Block 4B Central Park Adaptive Reuse

Modification to Concept Plan MP06_0171 MOD 16 and
State Significant Development Assessment SSD 9374

October 2020

NSW Department of Planning, Industry and Environment | dpie.nsw.gov.au

Figure 8 | Concept plan building heights, approved (left) and proposed (right), with proposed height changes clouded in red (Source: concept plan modification Architectural Plans)

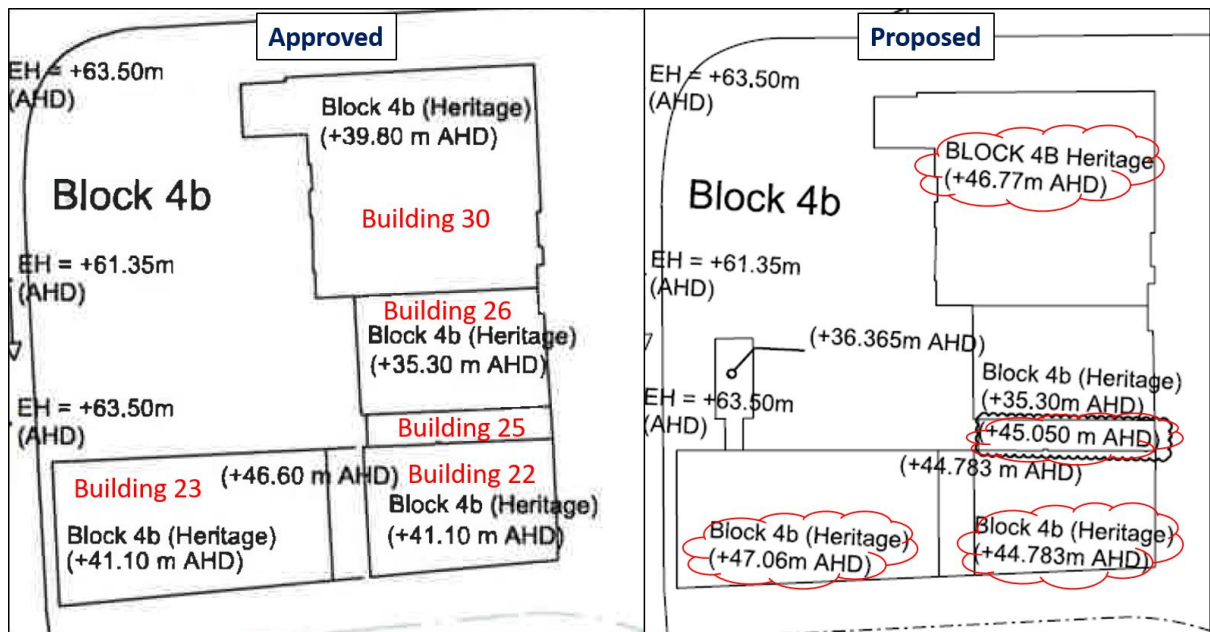
The modification application seeks to increase the maximum building heights of Block 4B to reflect the existing height of the Brewery Yard buildings and to accommodate a roof addition proposed for Buildings 22 and 23 under SSD 9374 (**Table 7**). The Applicant advises these changes will also correct previous survey errors and update the maximum height to reflect the constructed building heights.

The Department notes proposal does not seek any increase to the existing height of building 23 or the existing concept approval height of building 26 (**Table 7** and **Figure 8**) and therefore is satisfied that these aspects do not require further assessment.

The Department has therefore assessed the proposed amendments to Building 22, 25 and 30.

Figure 9 | South elevation, existing building heights for building 22 & 23 (red line) proposed heights (yellow) (Source: SSD 9374 Architectural Plans)

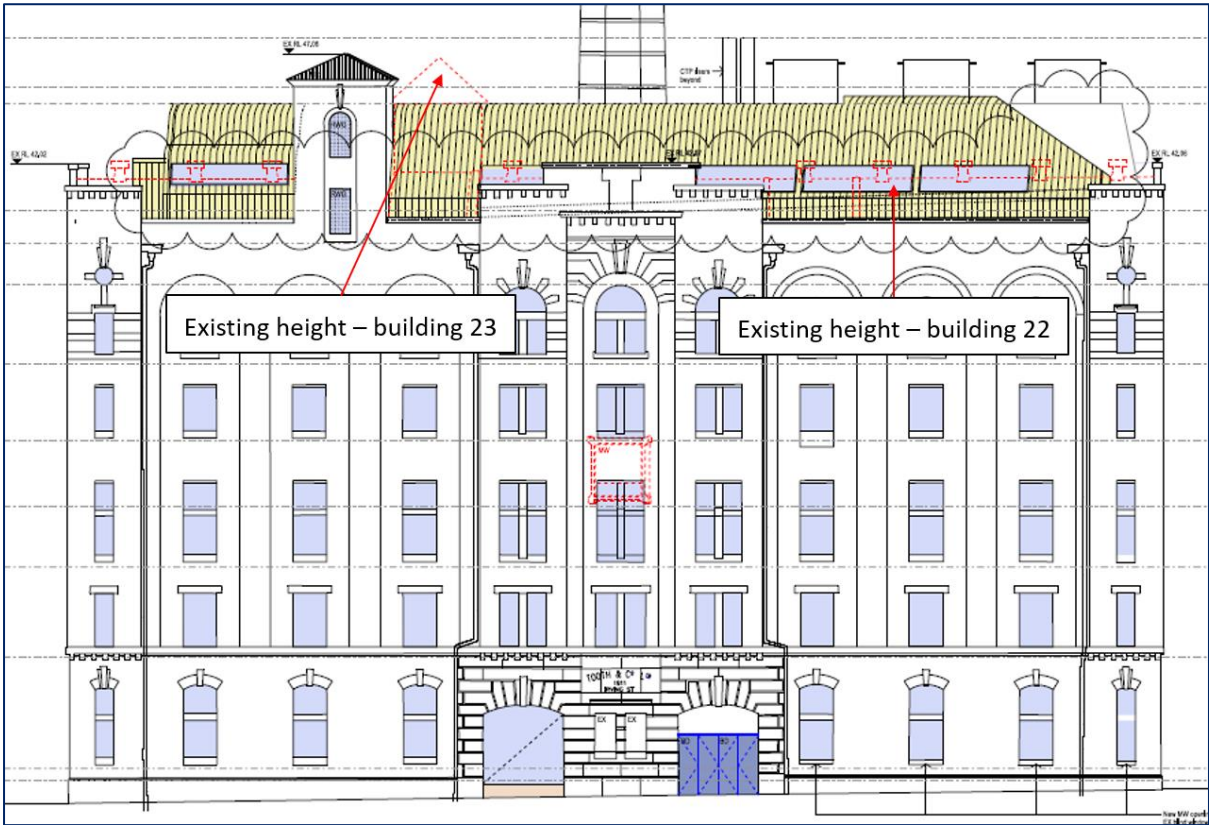
The proposal seeks to increase the existing building height of Building 22, by 2.72 m to RL 44.783 m (**Figure 9** and **Figure 10**), to accommodate the roof addition proposed over Building 22/ 23 under SSD 9374, to provide additional office floorspace.

- the increased height will not adversely impact on the character and heritage of the Brewery Yard buildings as it has been located within the existing ridgeline of Building 22/ 23
- the proposal remains consistent with the concept approval sun access plane and will not result in any additional overshadowing of the Chippendale Green on 21 June
- it has assessed the roof addition in the concurrent SSD application (**Section 6.3.3**) and concludes it will result in minimal visual impacts as it will be partly obscured behind the parapet and not visible from Chippendale Green.

Figure 10 | East elevation, existing building heights for building 23, 25 & 30 and proposed heights (Source: SSD 9374 Architectural Plans)

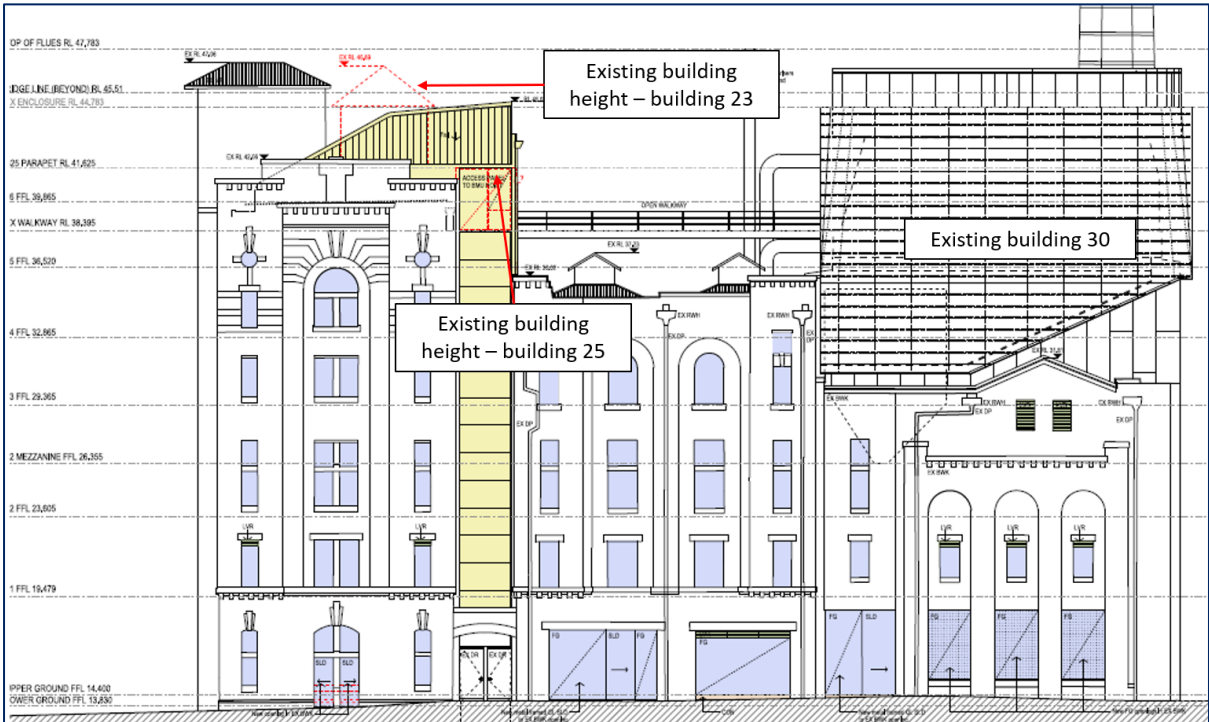
The concept plan does not currently identify a maximum height for Building 25. The proposal seeks to nominate a height of RL 45.050 (3.425 m higher than the existing building) to accommodate the eastern stair associated with the roof addition proposed under SSD 9374 (**Figure 10**).

The Department supports the proposed increase in height as there is no adverse impact on the heritage fabric of the Brewery Yard buildings, it will not result in any additional overshadowing of the Chippendale Green on 21 June and the height is integrated with the roof addition over Building 22/23 (**Section 6.3.3**).

Figure 11 | North elevation, existing building heights of building 30 CTP and proposed height in blue (Source: SSD 9374 Architectural Plans)

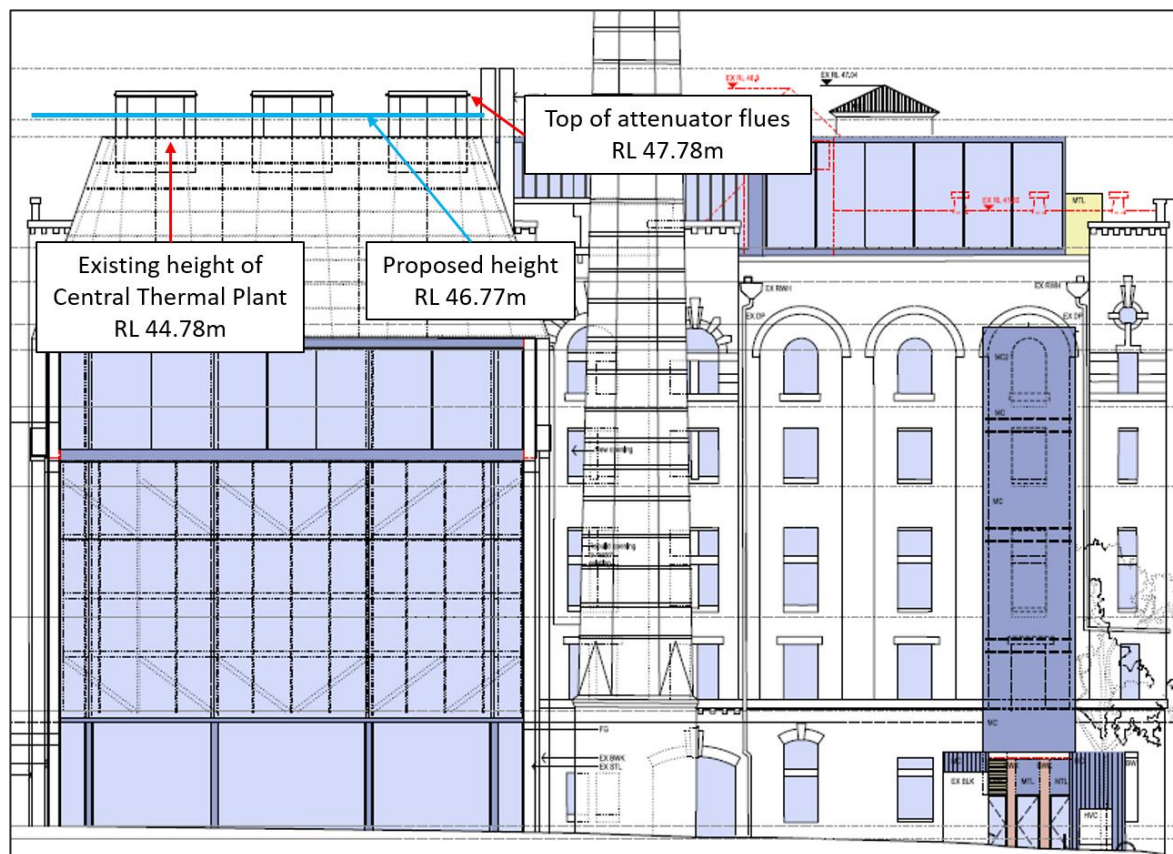
The proposal seeks to increase the approved concept plan height of Building 30 by 6.97 m to RL 46.77m, however this is 1.01 m below the existing attenuator flues (47.78 m) associated with the central thermal plant (CTP) and 1.99 m higher than the top of CTP (44.78 m) (**Figure 11**).

The Department notes that Building 30 contains the CTP roof plant within a sculptural roof element and the increase in height seeks to represent the height of the CTP addition already approved and constructed. No physical changes to the height of this building are being sought under SSD 9374.

Figure 13 | View of coal hoppers from the public domain (Source: RRFI 4)

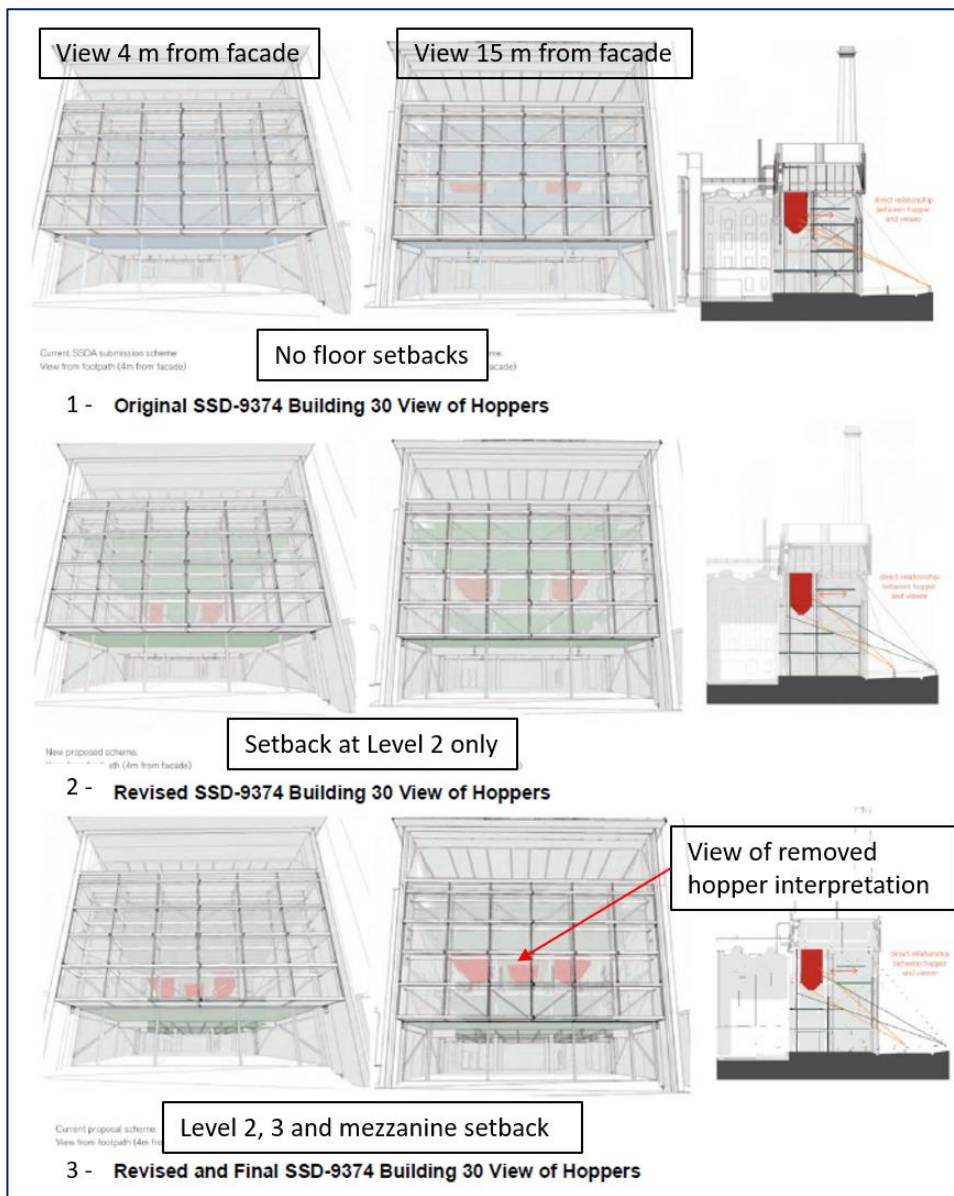
Building 30 currently contains three existing former coal hoppers (**Figure 12**), which were added in the mid 1950's when coal was used to create steam for the brewing process and for the generation of electricity. The coal hoppers have high significance as they demonstrate the industrial processes that occurred on the site.

The proposal includes the removal of the central hopper in Building 30 to provide two levels of additional commercial floorspace.

The DIP acknowledges the removal of one coal hopper will reduce the capacity to demonstrate and appreciate the full scale of the industrial nature and operation of this part of Building 30. However, it considers the additional floor space at level 3 and the mezzanine are important components of the proposal and considers that the creation of a different form of adapted industrial space in Building 30 is an acceptable outcome. The DIP supports the proposal, subject to interpretation to celebrate the presence and role of the removed hopper.

The Department notes that Council maintains its position that the three hoppers should be retained, and the additional floors deleted. However, after careful consideration of the proposal and the recommendations of the DIP, the Department supports the proposal as:

In response to Council's concerns, and the advice of the DIP, the Applicant has amended the proposal including redistributing internal floors and additional interpretation of the coal hoppers (**Figure 13**). The Applicant contends the amended proposal provides views of the hoppers from the public domain, the new floor space allows a more intimate interaction with the hoppers through new interior views and interpretative opportunities, while also providing floor space to support the feasibility of the proposal.

The Department has considered the amended proposal and the comments from Council and the DIP. The Department notes the significance of the coal hoppers and acknowledges that it would be desirable to retain all three hoppers. However, the Department also appreciates the Applicant's position that the floor space achieved by the removal of the central hopper and creation of additional floors is critical in achieving a viable development that facilitates the conservation of the buildings.

- the significance and understanding of the industrial use of Building 30 is not adversely affected as the remaining two hoppers are retained in-situ and this will allow interpretation of these significant elements
- there will be closer internal views of the retained coal hoppers from levels 2, 3 and the mezzanine, which is only possible from these additional levels
- the retained coal hoppers will be visible from the public domain due to the revised layout of the internal floors and additional setbacks at level 2, level 3 and the mezzanine (**Figure 13** and **Figure 14**)
- meaningful interpretation of the removed hopper will occur through the re-interpretation of the bottom of the middle hopper and proposed images on the chimney stack.

Figure 15 | Comparison of upper section of the glazed northern façade, 'bird's mouth' design (left) and current proposal (right) (Source: Applicant's RRFI 2 – Attachment 8)

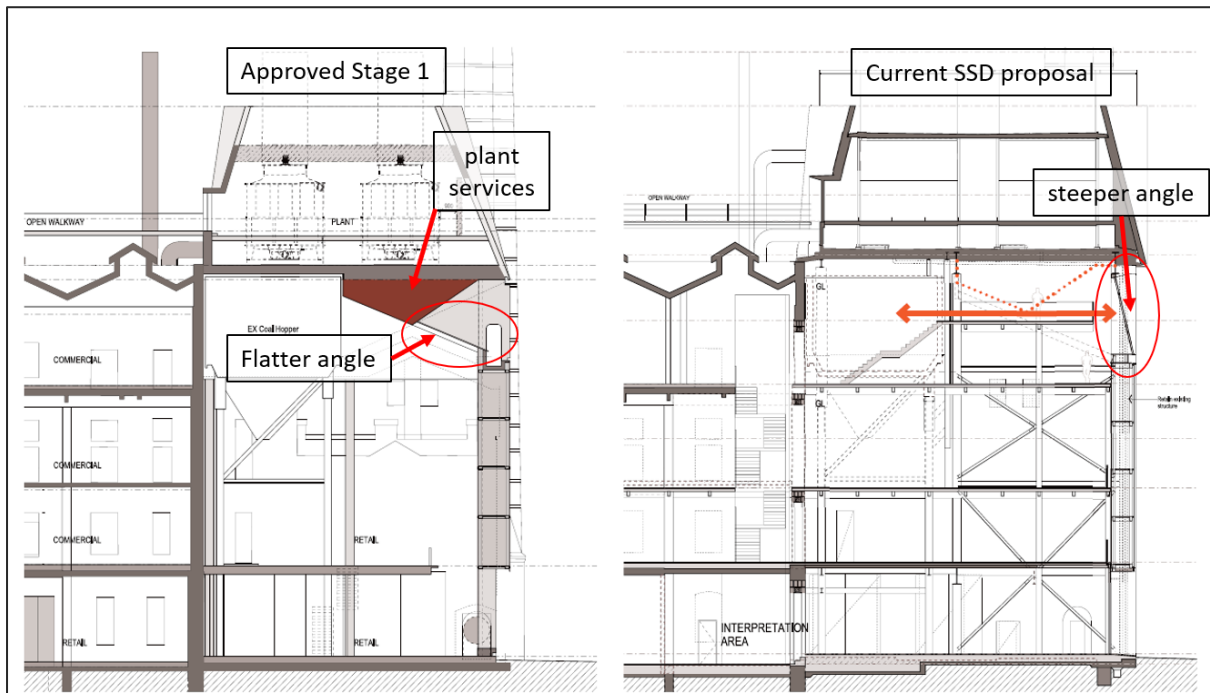
- Council does not support the change to the original approved design intent of the northern façade of Building 30. The design should be amended to retain the 'birds mouth' articulation.
- The additional columns to support the new floors also compromise the design quality of the building.
- Council considers the proposal has less design quality and higher heritage impacts than the previously approved development (MP10_0127)

The Applicant notes this glazed facade is similar to what was approved under MP 10_0217, but without the 'bird's mouth' feature at the top section of the glazing.

The Applicant advises the 'bird's mouth' (flatter angle of glazing) feature provided space for tri-generation plant services which were subsequently accommodated in the roof space, during the Stage 1 construction under MP 10_0217. The Applicant's proposed design does not include the 'bird's mouth' element at the upper section of the glazing, instead proposing a steeper angle (Error! Reference source not found. **Figure 15** and **16**).

The DIP supports the design of the glazed northern facade and considers the proposed steeper inwards angle on the upper section is a superior outcome than the current flatter slope, irrespective of the internal outcome for the building.

The Department has considered the design of the glazed northern facade, Council's comments and the advice of the DIP. The Department notes the 'birds mouth' was a design feature of the original approval, and in part developed as a solution to the required tri-generation plant services. The current proposal is unconstrained by services and provides the opportunity for additional commercial floor space.

- the facade retains the variation in the lower, central and upper elements and overall integrity of the previously approved scheme (Figure 16)
- the glazed facade continues to provide a contemporary response to the tri-generation cooling towers above and connects to and activates the facade within the surrounding urban environment (Figure 16)
- the glazed facade retains views of Building 30's interior including of significant building fabric including the coal hoppers
- the flatter angle of glazing is not visible from the public domain however, traces of previous rooflines are visible inside Building 30 and will allow for interpretation of the history of the structure (Figure 17)
- the design improves internal views of the upper level of the hoppers due to the reduced angle of the upper level glazing
- the design requires less maintenance than the previously approved 'bird's mouth'.

Figure 19 | Proposed swept path to access forecourt loading area (Source: Applicant's RRFI 2 – 5 August 2020)

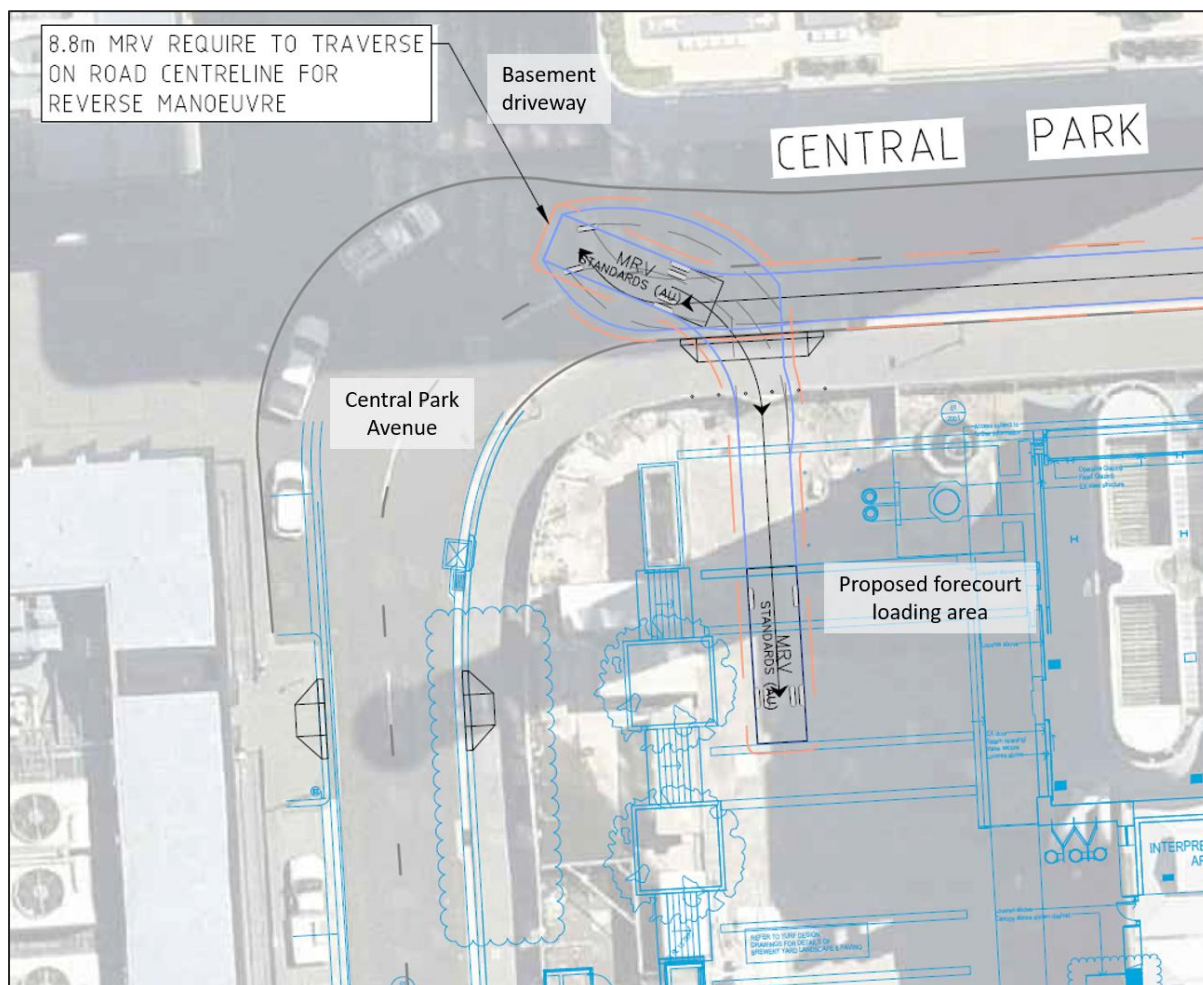
- Council continues to raise concerns about the loading zone and service vehicle requirements, including use of the existing 15 minute zone between Block 4s and 1
- Council does not support installing additional pedestrian ramp crossings
- Council recommends the Applicant provide clear documents showing new vehicle crossover locations and turning circles for vehicle size
- Council also notes the public domain and landscaping plans are inconsistent with amended architectural plans and should be updated.

The Applicant proposes to use the Brewery Yard forecourt for loading after business hours only, for waste collection and removal and deliveries of large furniture and appliances (Error! Reference source not found.Figure 19).

- pedestrian and traffic safety, as a truck must reverse into the loading area at a bend in Central Park Avenue, opposite an existing car park entrance and on a busy road (Error! Reference source not found.Figure 19)
- use of the forecourt for loading creates obstructions and is not consistent with the objectives of the Central Park concept approval to provide public open space.

The Applicant proposes to implement operational measures to manage the forecourt loading area including:

- ensuring loading activities occur outside of business hours during set times of the day (as developed with Council) when pedestrian and traffic activity is low
- vehicles must reverse in so they can exit in a forward direction and removable bollards to restrict vehicle access to the forecourt at all other times.

The Department has considered the concerns and comments raised by Council, however it supports the use of the forecourt for loading outside of business hours for the following reasons:
